**Economic and Social Council**Distr.: General
XX January 2024

World Forum for Harmonization of Vehicle Regulations**Working Party on General Safety Provisions****127th session**

Awareness of the Proximity of Vulnerable Road Users:**UN Regulation No. 166 (Close-Proximity to the Front and Lateral Sides of Vehicles)****Proposal for 01 series of amendments to UN Regulation No. 166 (Driver's Awareness of Vulnerable Road Users in Close-Proximity to the Front and Lateral Sides of Vehicles)****Submitted by the expert of the Informal Working Group on Awareness of Vulnerable Road Users Proximity (VRU-Proxi)**

The text reproduced below was prepared by the experts from the VRU-Proxi Informal Working Group (VRU-Proxi) to amend UN Regulation No. 166 for avoiding misunderstandings in the certification process. The modifications to the existing text are marked in bold for new or strikethrough for deleted characters.

Figure 1

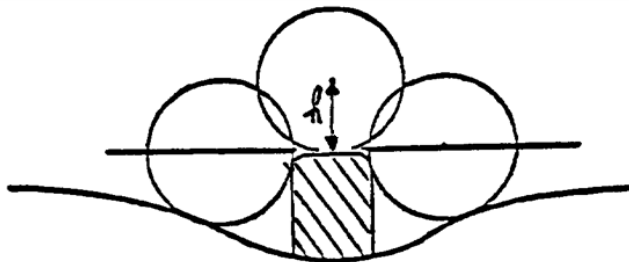
- 6.1.3.3.2. If the dimension of the projection of a component which is mounted on a surface other than convex cannot be determined by simple measurement, it shall be determined by the maximum variation of the distance of the centre of a 100 mm diameter sphere from the nominal line of the panel when the sphere is moved over and is in constant contact with that component.

Figure 1 shows an example of the use of this procedure.

Addition of impact safety requirements for mirrors copied from the UN regulation No.46 and exempt the devices approved by UN regulation No.26 or No.61.

Figure 2

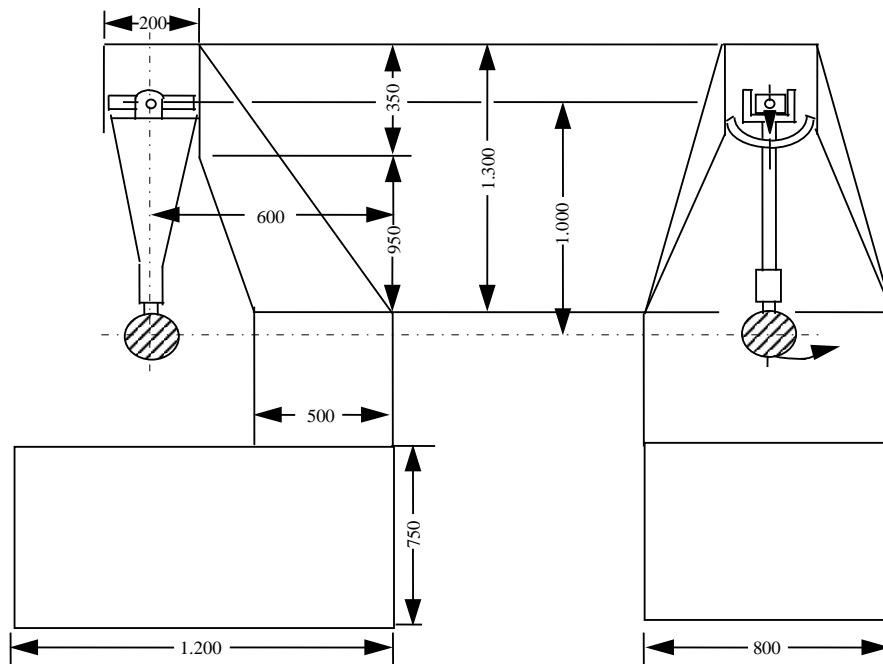
Figure 2 below gives the dimensions (in mm) of the test rig and the special design specifications:

6.2.2.1.2. The centre of percussion of the pendulum coincides with the centre of the sphere, which forms the hammer. It is at a distance l from the axis of oscillation in the release plane, which is equal to $1\text{ m} \pm 5\text{ mm}$. The reduced mass of the pendulum is $m_o = 6.8 \pm 0.05$ kilograms. The relationship of m_o to the total mass m of the pendulum and to the distance d between the centre of gravity of the pendulum and its axis of rotation is expressed in the equation:

Figure 3

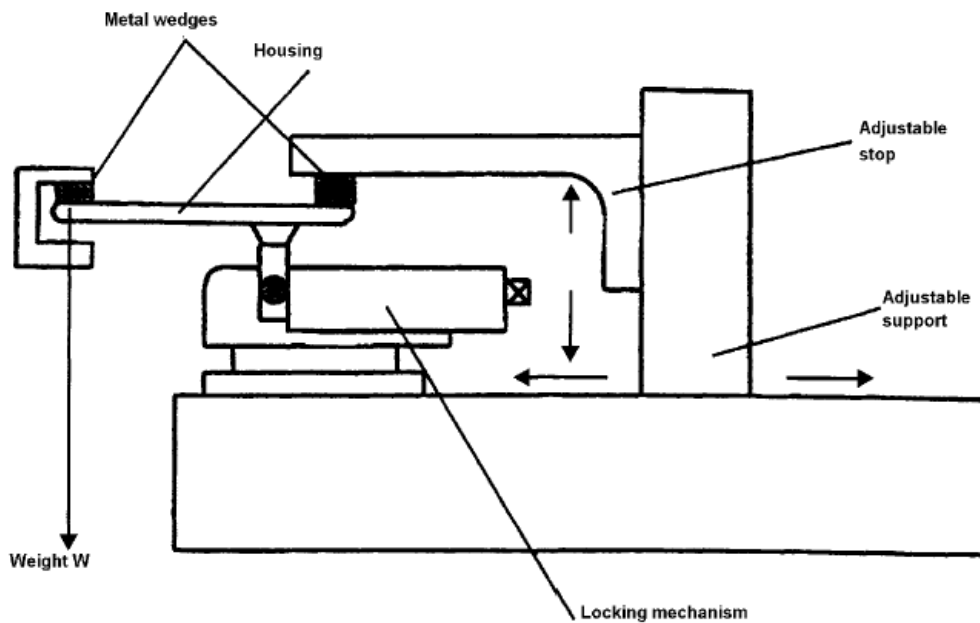
The protective housing is placed horizontally in a device in such a way that it is possible to lock the attachment support adjusters firmly. In the direction of the largest dimension of the housing, the end closest to the point of attachment on the adjuster for the support shall be immobilized by a 15 mm-wide rigid stop covering the entire width of the housing.

At the other end, a stop identical to the one described above is placed on the housing so that the specified test load can be applied to it (Figure 3).

The end of the housing opposite to that where the force is exerted may be locked rather than held in position as shown in Figure 3.

Figure 4

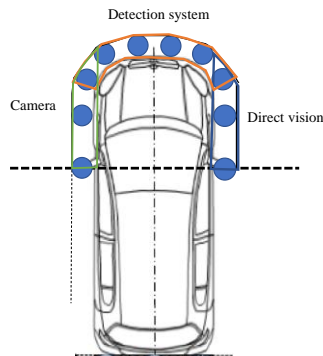
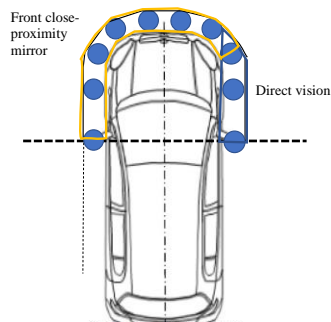
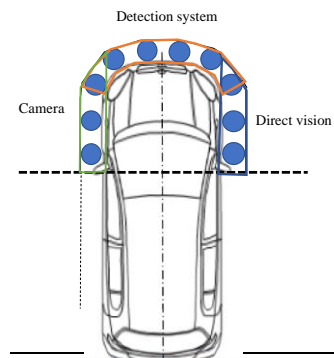
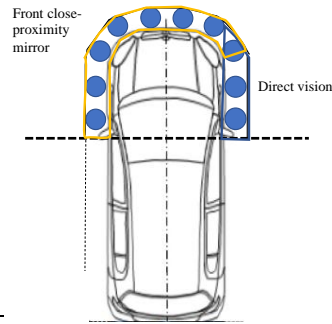
Overlaps of designated areas by different means (see examples in Figure 4) shall be permitted.

Delete Paragraphs 15.2.2., 15.2.3, Figure 3 and 15.2.4.

Reorganized between two paragraphs 15.1 and 15.2 for misunderstanding and clear descriptions. Figures were updated about pole location at center of side mirror for misinterpretation.

Figure 5

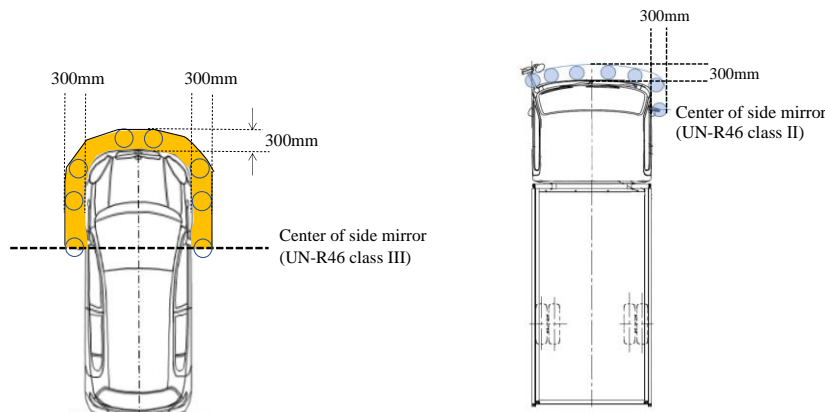
Paragraph 15.2., amend and delete Figure 2, to read:

The field of vision (see Figure 5 below) shall be bounded by the following planes:

- (a) A **longitudinal** ~~transverse~~ vertical plane passing through a point 300 mm from the contour of the sides of the vehicle;
- (b) A transverse **vertical** ~~horizontal~~ plane passing through a point 300 mm from the contour of the front of the vehicle;
- (c) Areas ahead of the centre of the side mirrors on the driver's seat side and the passenger seat side. In the case of the vehicle that equipped with CMS that comply UN Regulation No. 46, 04 Series of amendments, the manufacturer shall consider the same vehicle equipped with side mirrors or to use the centre of Class III or II CMS camera lens instead of the centre of the side mirrors.

Figure 6

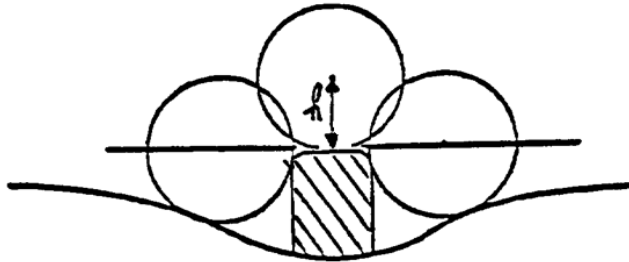
15.4.3.3.2. If the dimension of the projection of a component which is mounted on a surface other than convex cannot be determined by simple measurement, it shall be determined by the maximum variation of the distance of the centre of a 100 mm diameter sphere from the nominal line of the panel when the sphere is moved over and is in constant contact with that component.

Figure 6 shows an example of the use of this procedure.

Addition of impact safety requirements for FLVCS and Detection system same as mirror (6.1.3.).

Replace Figure of Annex 5, to read:

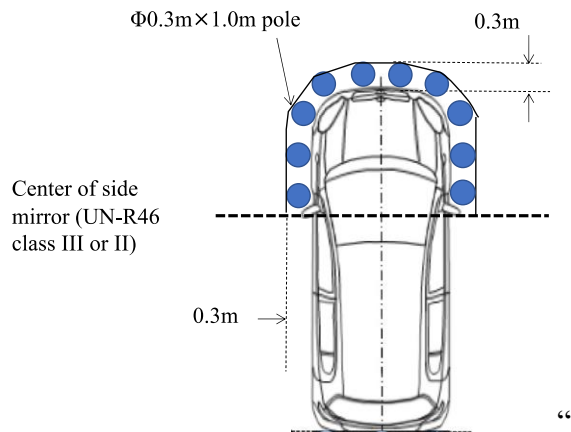
“The above approval mark affixed to a device for means of front and lateral vision indicates that the device is a main close-proximity front and lateral view device, which has been approved in Japan (E 43) pursuant to UN Regulation No. 166 and under approval number ~~002439~~**012439**. The first two digits of the approval number indicate that **UN Regulation No.166 already included the 01 series of amendments when** the approval was granted ~~in accordance with the requirements of UN Regulation No. 166 in its original form.~~ “

Corrected to fit 01 series of amendment.
